Conceptual Review Agenda

Schedule for 08/17/15 to 08/17/15

Mulberry and Lemay Crossing Drive-Thru Restaurant

Re: Mulberry and Lemay Crossing - Drive-Thru Restaurant

PROPOSED FAST FOOD
RESTAURANT CONCEPT PLAN
DRIVE THRU ALONG LEMAY

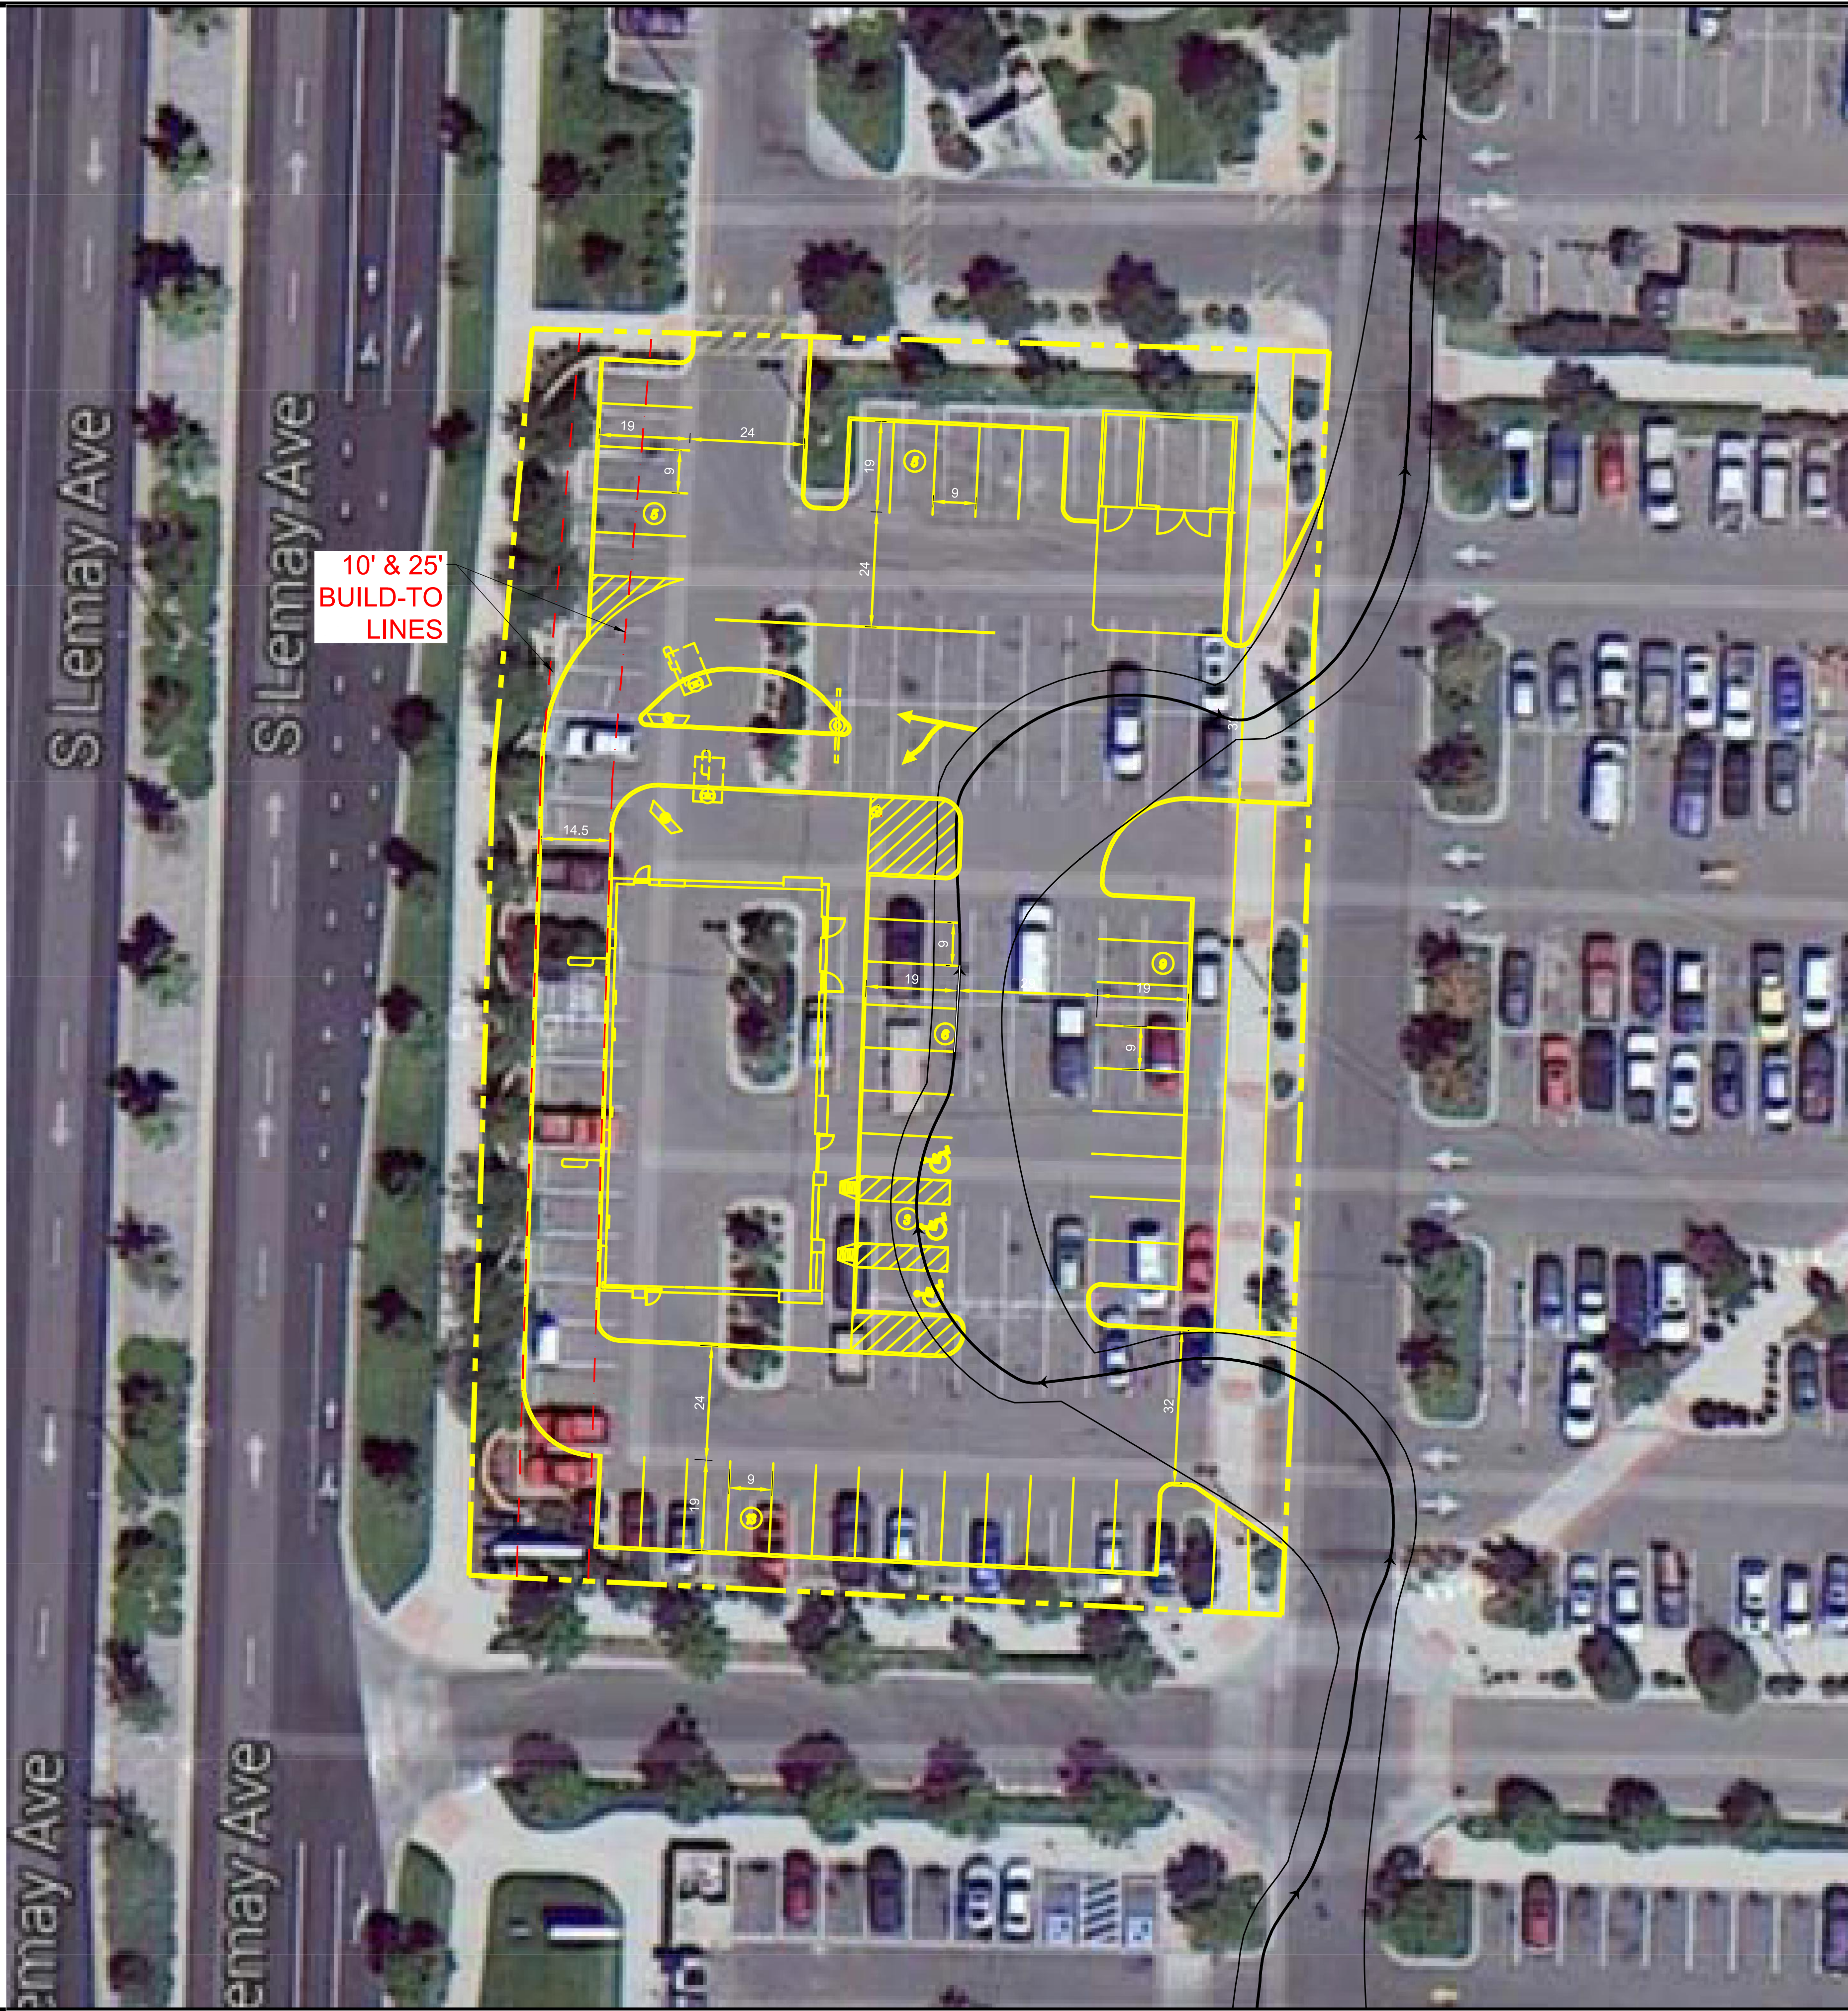
1. There will be vehicular conflict at driveway to the north serving Taco Bell serving both their drive thru and customer parking to the west of their building. At peak times this lane can be backed up to and including the n-s lane it intersects with. Taco Bell parking customers often have to cut over to the proposed site to exit meaning impact there. An analysis of the exiting and potential conflict should be looked at and addressed.

1. Since this site was never originally planned as a pad site with the overall development, the traffic impacts associated with a drive-through restaurant were not analyzed. A Transportation Impact Study will be needed. Please contact Martina Wilkinson to scope the extent of the traffic study.

1. As noted in the narrative, there is a drive-through lane located between Lemay Avenue and the proposed building. This is in violation of one of the Land Use Code's most fundamental site planning standards. The standard, Section 3.5.3(B) states:

The proposed site plan fails to comply with this standard.

The proposed site plan fails to comply with this standard. Placing commercial buildings along streets such that the building fronts the street versus vehicular use areas is a primary standard for establishing the desired urban design for our City.

3. The drive-through lane, the menu board, the pick-up windows and headlight glare are all elements of the site plan that are considered to be areas of low visual interest and yet they are all located along the Lemay Avenue frontage. The narrative indicates that the low screen wall and double row of street trees are sufficient to screen the west side of the building. Please note that this wall and street trees were specifically designed to mitigate the Home Depot parking lot, not the drive-through lane component of a drive-through restaurant.
4. The standards in the Land Use Code are specifically intended to be adhered to by applicants to the maximum extent feasible. According to Section 5.1.2, this means:

1 ARCHITECTURAL SITE PLAN
1" = 10'-0"

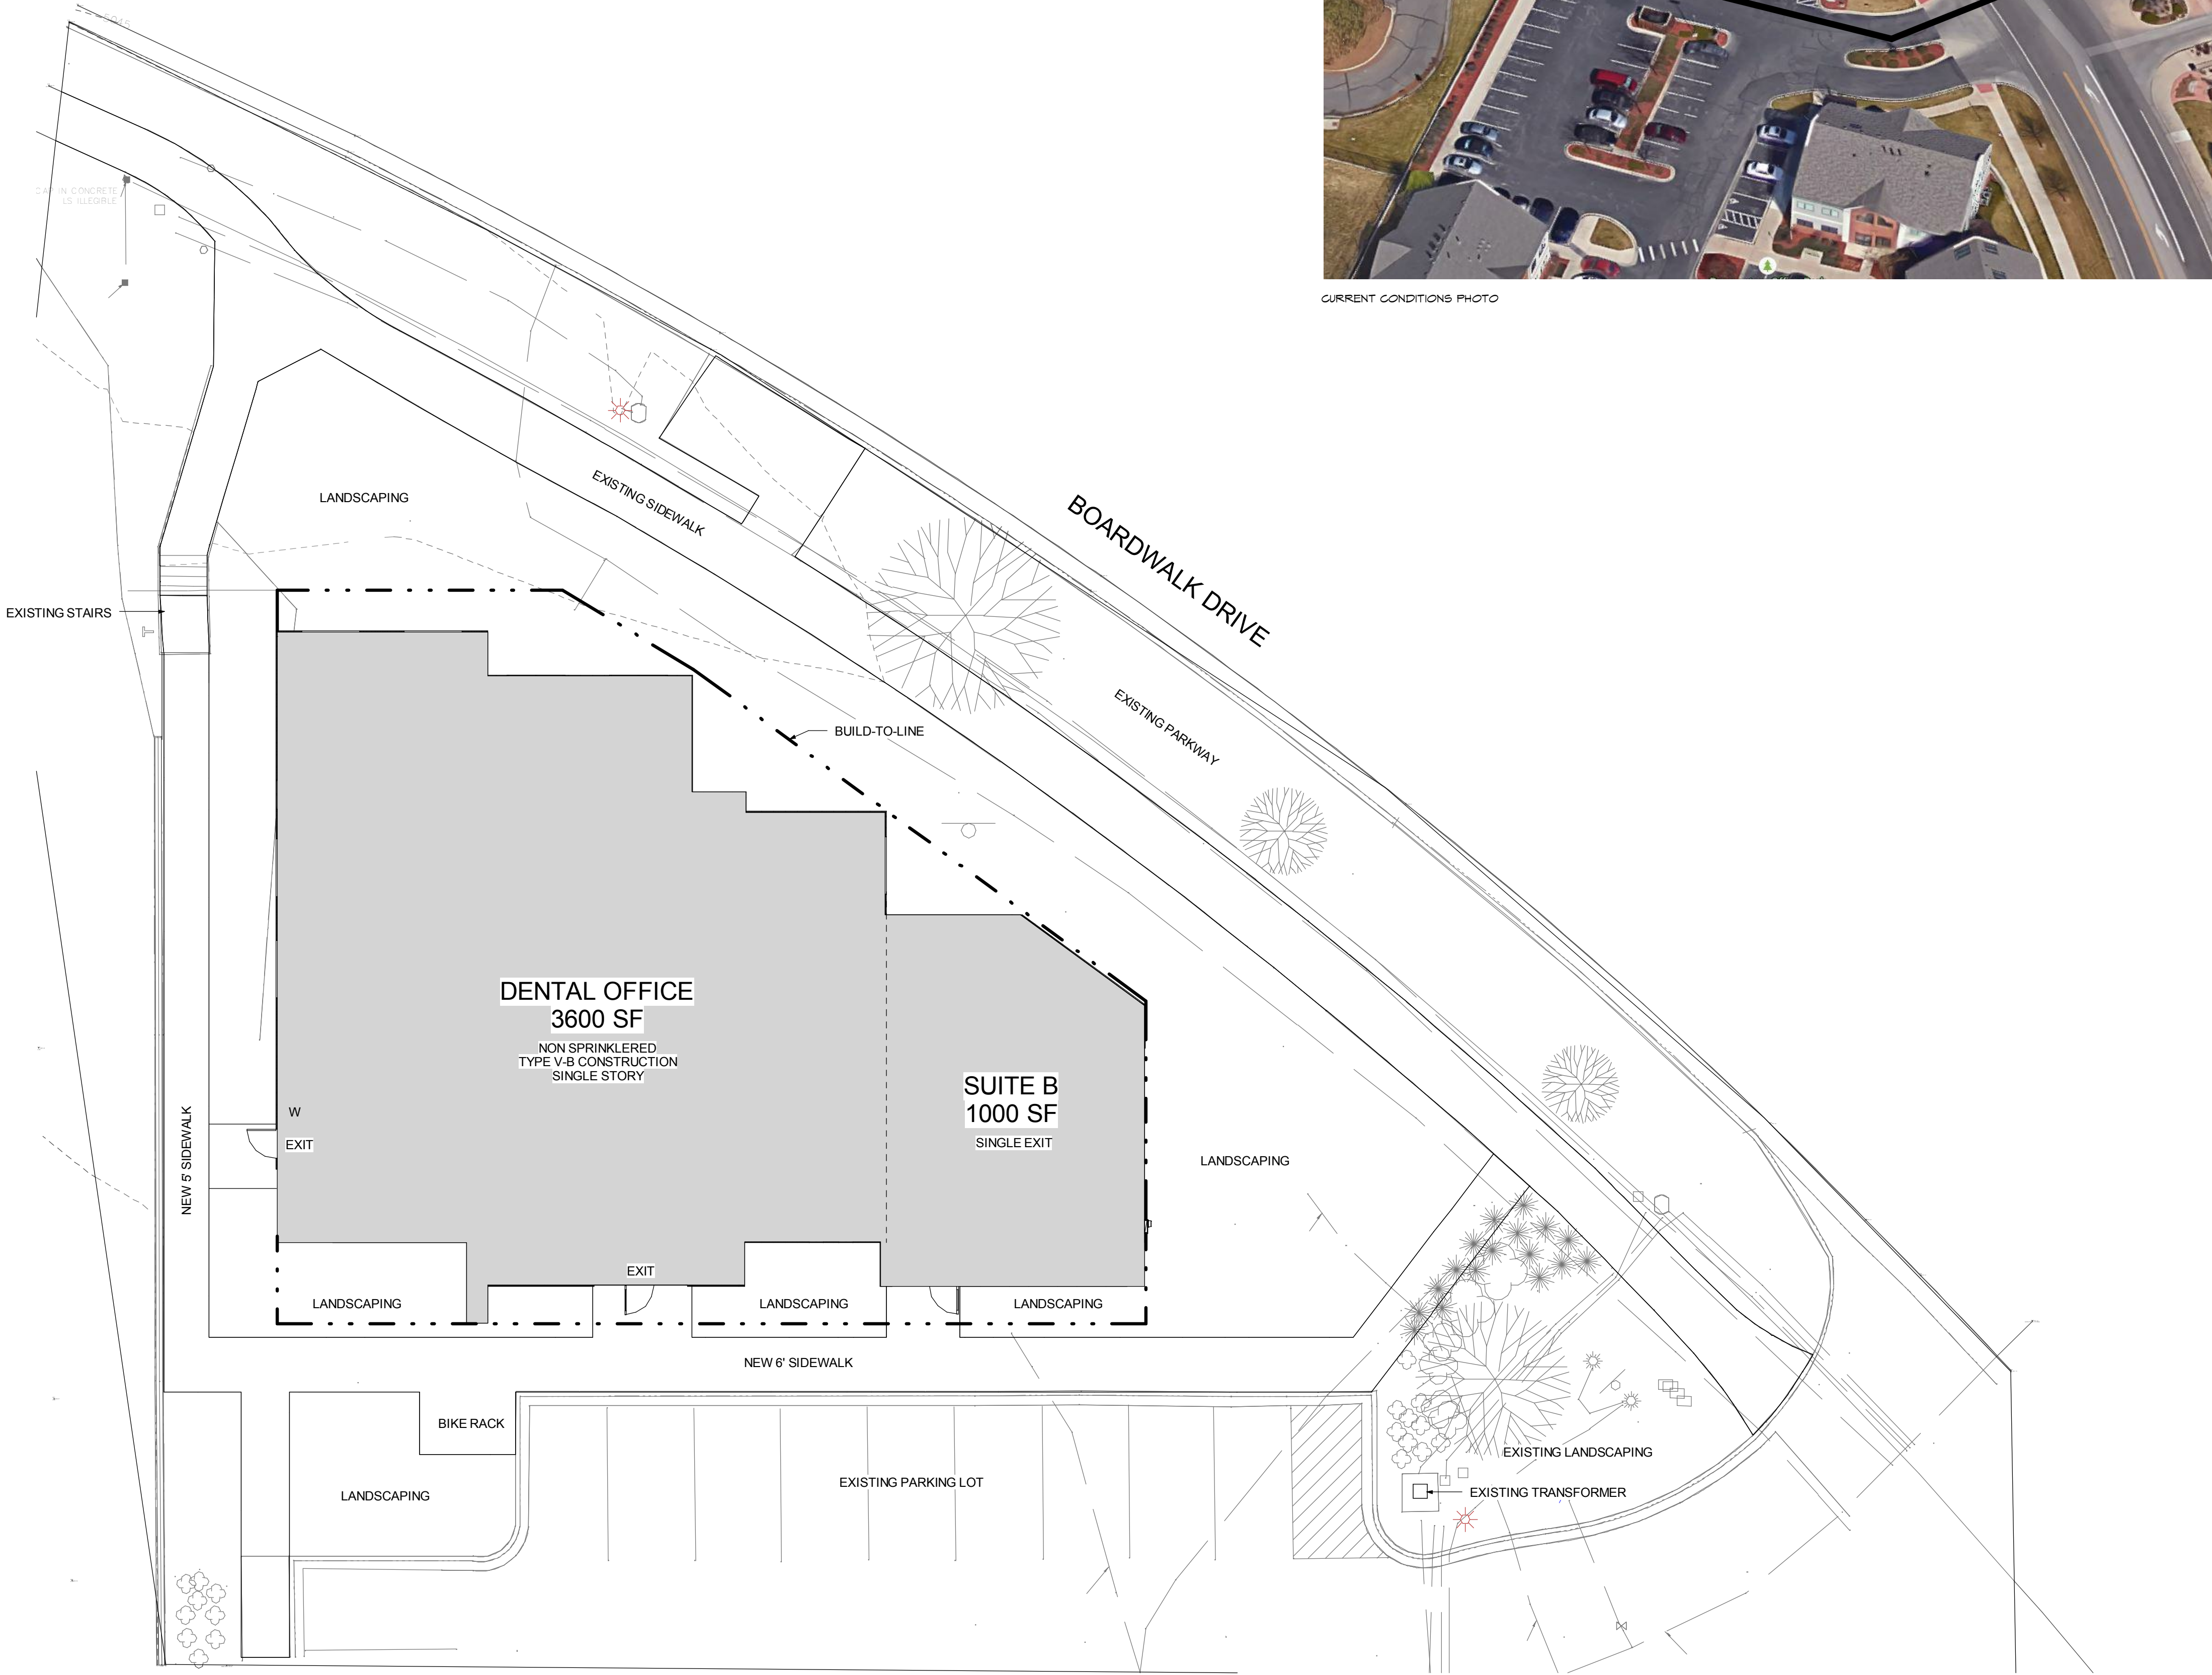
1. Please note that that Promontory is located in the Residential Neighborhood Sign District as a Convenience Shopping Center with any exterior signs subject to sign standards found in LUC 3.8.7(E).
2. Are there plans to provide for a trash enclosure? If so the enclosure must meet LUC 3.2.5.
3. Overhangs are not permitted over public easements.

1. You will need to provide 8 bike parking spaces per Land Use Code section 3.2.2(C)(4). 6 can be provided via fixed rack with 2 enclosed parking spaces.
2. The proposed building must meet the standards outlined in section 3.5.3 of the Land Use Code.
3. The proposed development is subject to a Minor Amendment Review, please contact the Zoning Department regarding your formal submittal.
